FHWA REGION NO.	STATE	PROJECT NO.	YEAR	SHEET NO.	TOTAL SHEETS
7	KANSAS	54-87 K-6657-01	2002	130	1122

No.	Revisions	By	Date
CITY OF WICHITA			
PAVING BRICK & MEDIAN NOSE DETAILS			
SEDGWICK COUNTY			
Professional Engineering Consultants, P.A. <small>303 S. TOPEKA • WICHITA, KANSAS 67202 316-262-2691 • FAX 316-262-3003</small>			
Designed by	WDH	Checked by	WDH
Drawn by	JGP	Date	Apr 11, 2002 Job No. 97362

PAVING BRICK (MEDIAN) & (PARKING)

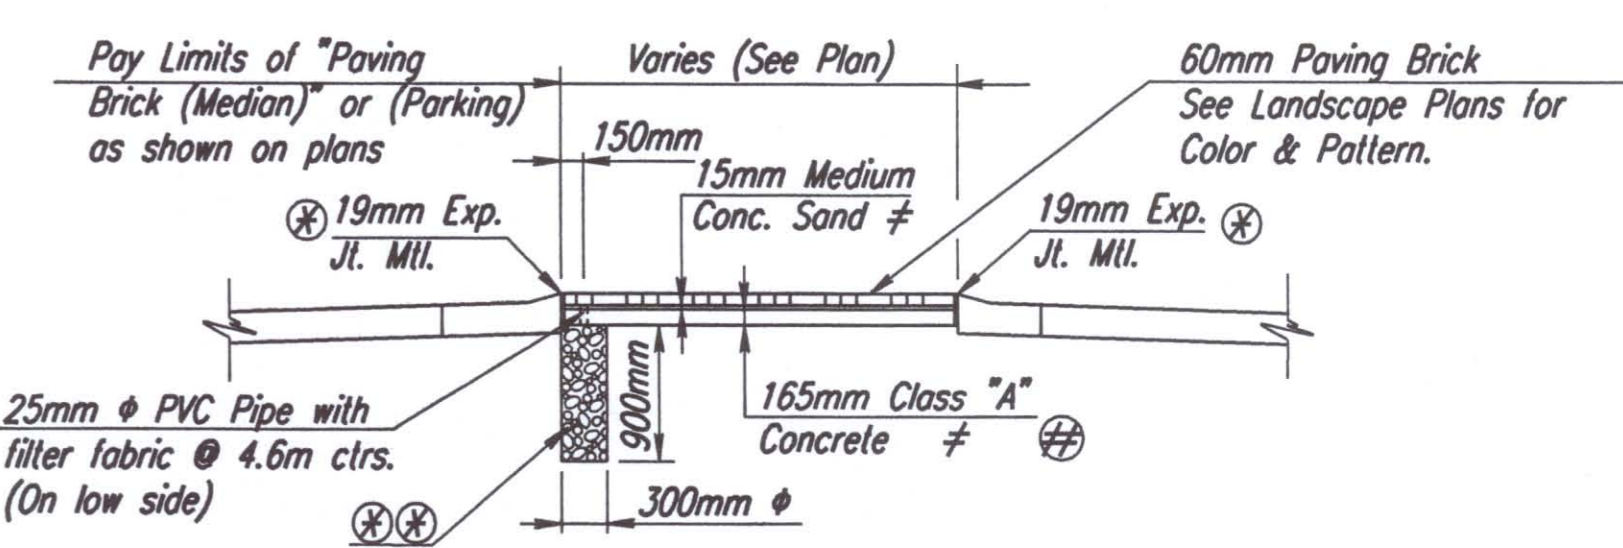
Paving Brick (Parking)
 ⊕ Substitute AB-1 base material where specified as Paving Brick (Parking). Delete 25mm weepholes and underdrain holes. Provide Expansion Joint material between pavers & curb. Contractor ~~may~~ substituted 3/4" concrete rock with filter fabric on top for AB-1.
